ADDENDUM NO.   1   DATED   1/21/2014   ADDENDUM NO.        DATED         
 ADDENDUM NO.        DATED        ADDENDUM NO.        DATED

Number	Description
1	Revised Table of Contents; Add SP 907-682-10; Revised Wage Rates; Revised BidItems; Revised or Added Plan Sheet Nos. 2, 6, 15, 2001, 2002, & 2003; Amendment EBS Download Required.

# MISSISSIPPI DEPARTMENT OF TRANSPORTATION

### PROJECT: NH-0055-02(236) / 106483301 – Hinds County

WORKING NUMBER  
**SQ-4**

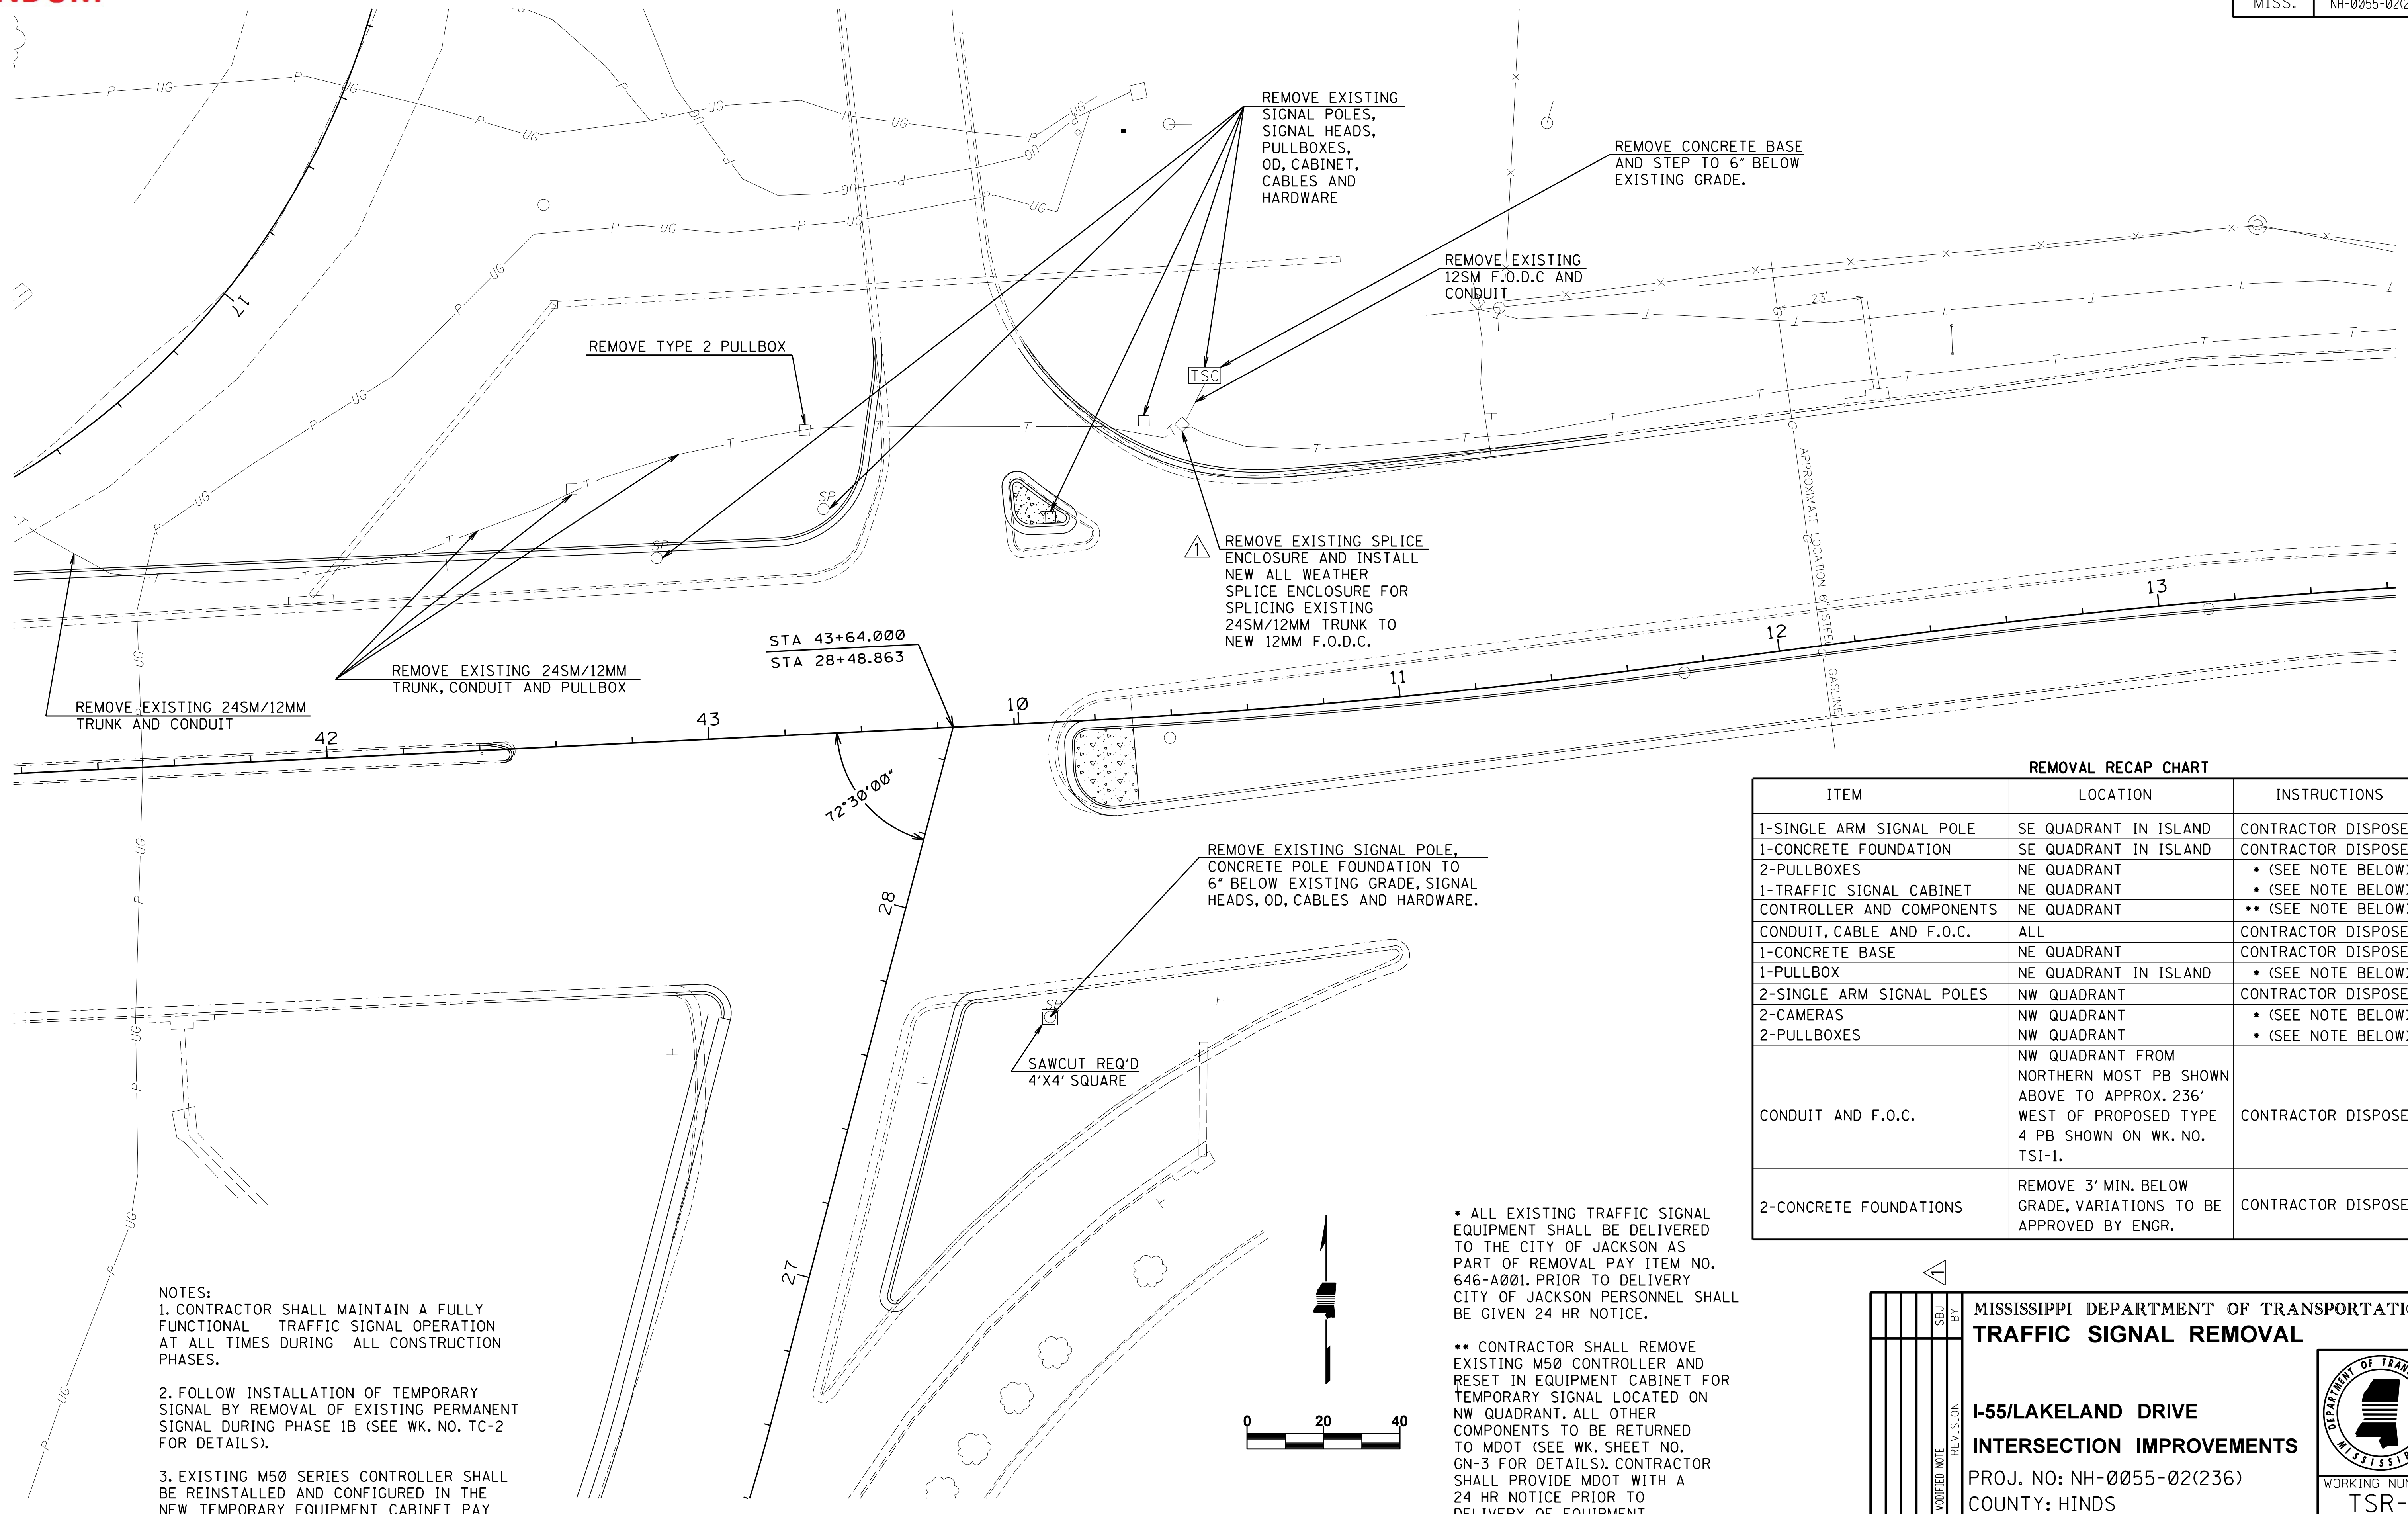
REMOVED AND ADDED PAY ITEMS, ADDED FOOTNOTES, CHANGED QUANTITY	DATE	BY	MISSISSIPPI DEPARTMENT OF TRANSPORTATION <b>SUMMARY OF QUANTITIES</b>
01/15/14			<b>I-55/LAKELAND DRIVE INTERSECTION IMPROVEMENTS</b>
			PROJ. NO. NH-0055-02(236)
			COUNTY: HINDS
			FILENAME: SQ-1.DGN
			DESIGN TEAM STANTEC CHECKED DATE
